Applicant-Proposed Changes to:

**SITE CERTIFICATION AGREEMENT  
FOR THE HORSE HEAVEN WIND FARM**

**HORSE HEAVEN WIND FARM, LLC**

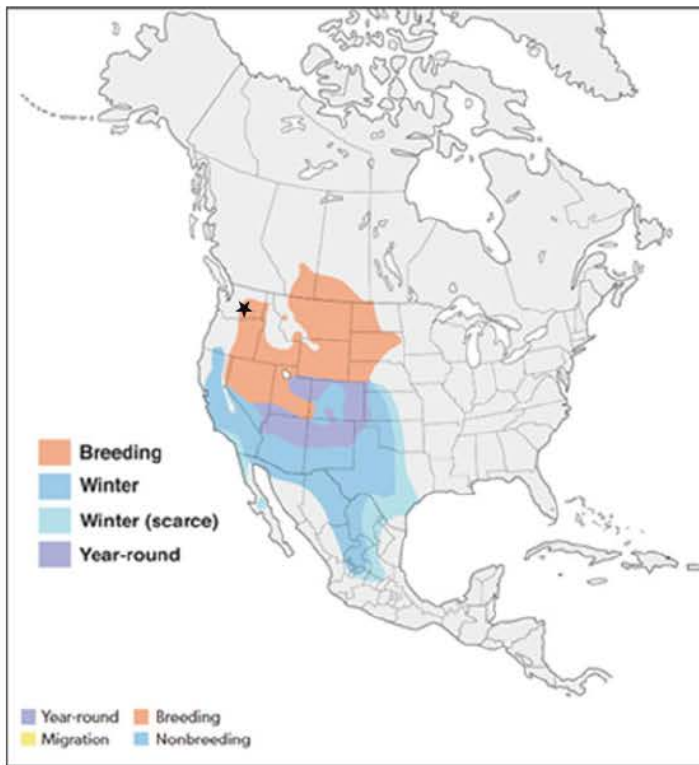
Moreover, the larger, 2-mile exclusion buffer for wind turbines is unwarranted and unsupported in the record. The Council incorrectly assumes that wind turbine presence (and even passive solar arrays or BESS) would deter future nesting, but that large-scale residential development, active farming, and other land disturbances somehow do not. In actuality, FEHA's primary threat here is key foraging habitat loss from sprawling residential and agricultural land conversion, which has been occurring for decades with no end in sight, *not* turbine strikes or primary component installation and operation. As Counsel for Environment's (CFE) biology expert Don McIvor explained, "the probability of a strike is low."<sup>16</sup> Thus, at present in the area, wind turbines pose no more risk to the FEHA species than any other type of land development. And here, *unlike with sprawling (county-permitted) residential and agricultural development*, Scout assumes substantial responsibility to invest in concrete conservation actions and adaptive management. The substantial evidence and the FEIS support adaptive management practices to minimize strike risk in response to any FEHA nesting in the Project Area, *not* complete elimination of turbines within the buffers.

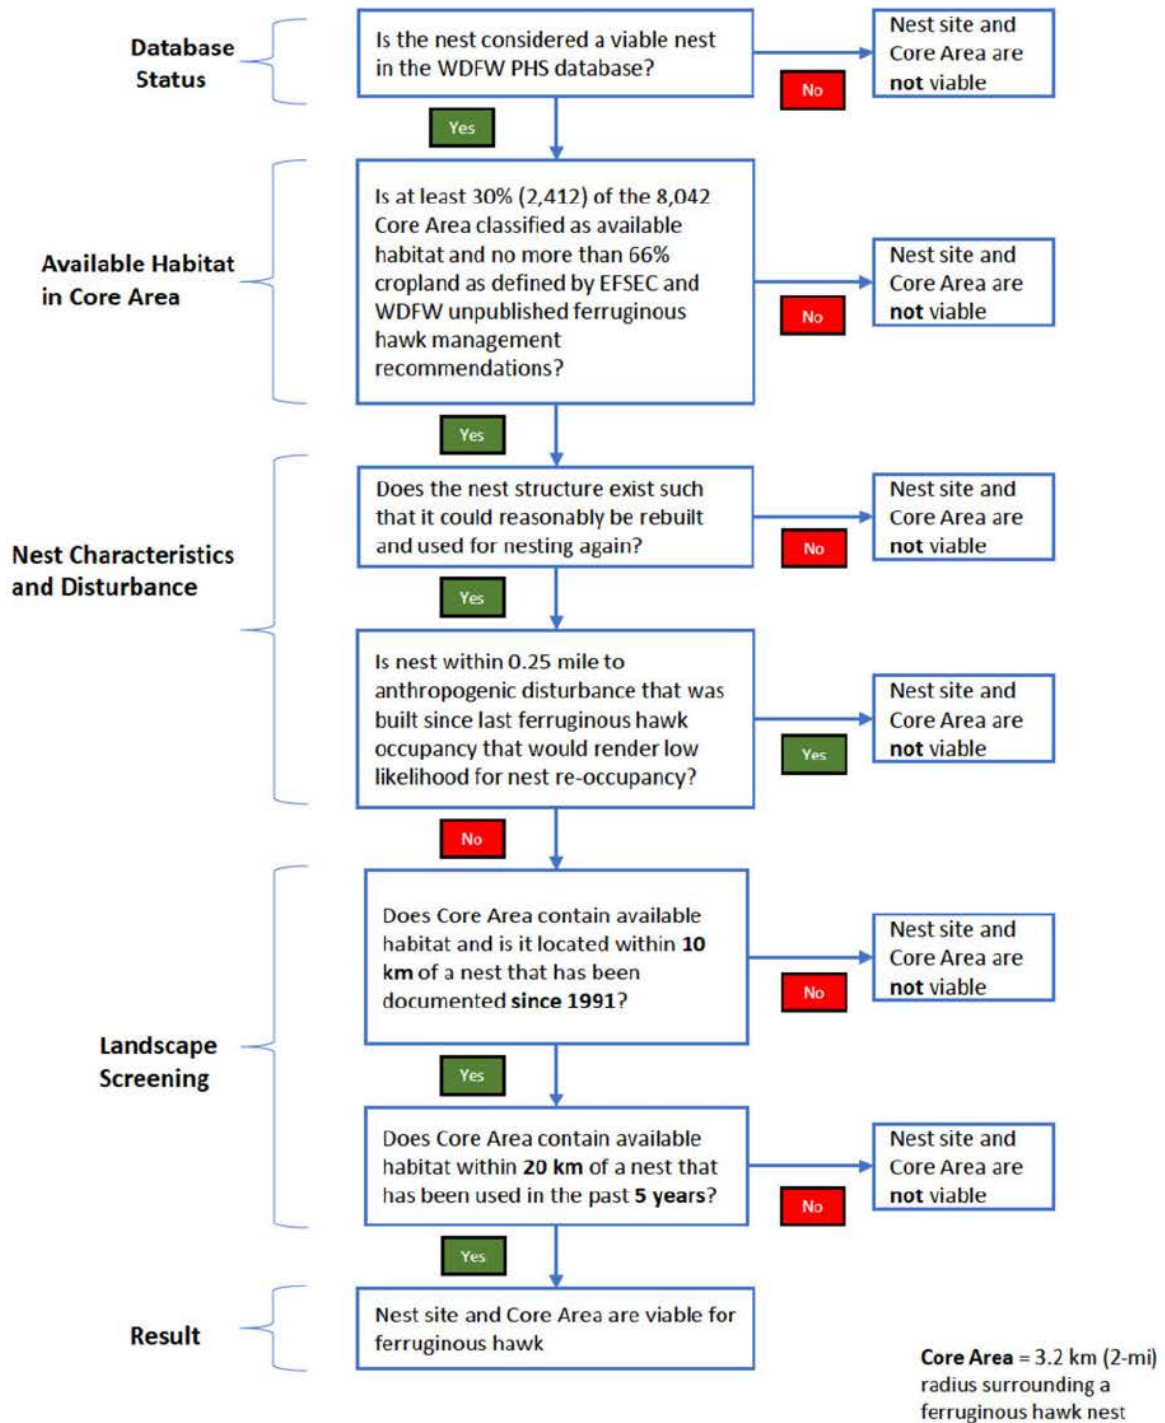
by Scout in previous submittals to EFSEC staff. ***Second***, the measure does not specify when associated “foraging habitat” is “no longer available.” That is to say, Spec-5 provides no habitat threshold that would render “foraging habitat” no longer viable for use by FEHA. WDFW has stated that FEHA home range has less than 30% cropland<sup>25</sup> and has at least 50% shrub-steppe habitat.<sup>26</sup> Scout proposes Spec-5 be clarified to define “available foraging habitat” to require a maximum of 30% cropland and minimum of 50% shrub-steppe or grassland habitat within 2 miles of a FEHA nest site, as identified by WDFW. This approach utilizes WDFW’s existing habitat profile percentages, with the addition of grassland, which according to even WDFW’s unpublished FEHA management recommendations is a valuable habitat type for FEHA.<sup>27</sup>

Below is a more specific analysis provided by Scout and its biologists in previous submittals to EFSEC staff, which includes proposed language to reduce ambiguity and decrease the likelihood scientists will need to debate over FEHA nest availability. These proposed criteria, also provided in the January Comments at p. 19, are objective and rooted in established biological understanding to facilitate a streamlined and non-adversarial viability assessment process.

Figure 1. The frequency of avian studies from around the world and that showed a behavioral response (species avoidance and reduced density) by corresponding distance from the infrastructure (Benitez-Lopez 2010).

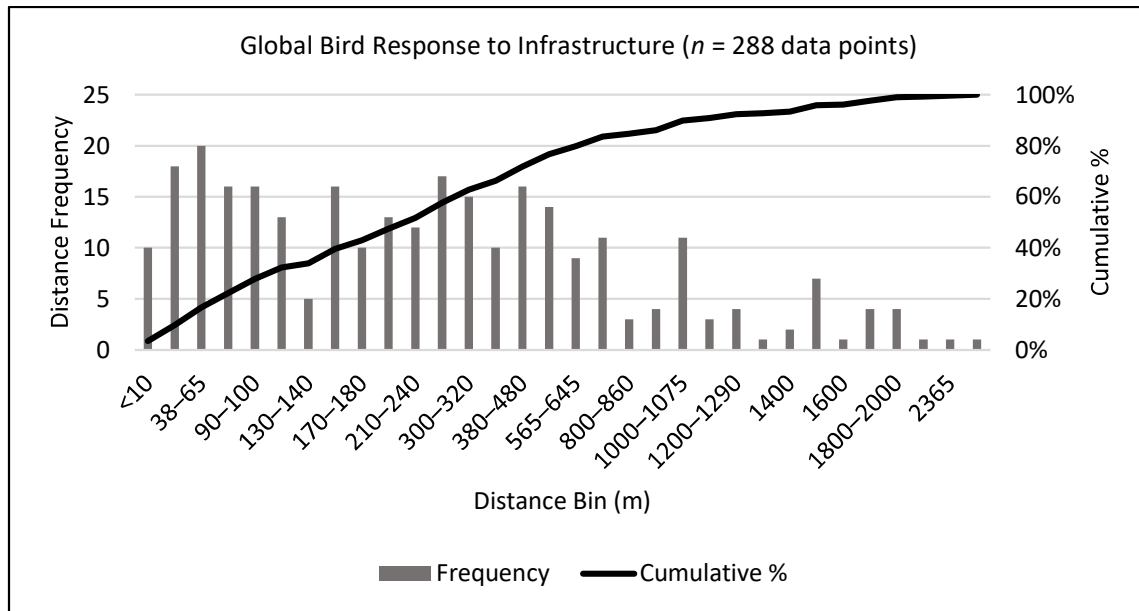
Second, the DEIS does not provide justification for how the 0.5 mi (800 m) threshold for species responses was determined. The majority (>50%) of bird species in Benitez-Lopez (2010) showed a behavioral response within 0.15 mi (240 m) of infrastructure (Figure 1). These shorter distances are more representative of grassland bird responses (262-328 ft [80-100 m]) cited earlier in the text (§4-160) and more representative of the species groups found at the Project (Leddy et al. 1999, Johnson et al. 2000, Erickson et al. 2004, Shaffer and Buhl 2016).

Third, Benitez-Lopez (2010) do not differentiate between types of infrastructure and grouped them together in the analysis. For example, Benitez-Lopez (2010) treated roads that receive 10 vehicles / week (Develey and Stouffer 2001) similar to roads that receive 52,000 vehicles /day (Meunier et al. 1999). The application of these types of studies in comparison with pre- or post-construction conditions at the Project has little merit and relevance.

Finally, the DEIS relies on studies one to two decades old, if not older in some cases, to characterize bird responses to anthropogenic sources. The DEIS dismisses a large body of more recent peer-reviewed scientific literature (Carlin and Chalfoun 2021, Hale et al. 2014, Hatchett et al. 2013, Mahoney and Chalfoun 2016, Miao et al. 2019, Marques et al. 2021, to name a few). Failure to incorporate more recent species and regionally appropriate science does not incorporate the best available science when attempting to evaluate indirect effects from renewable energy infrastructure on wildlife species. For these reasons, the broad generalizations and unproven scientific extrapolations do not provide a strong enough justification for the definitive application of the ZOI in the DEIS.
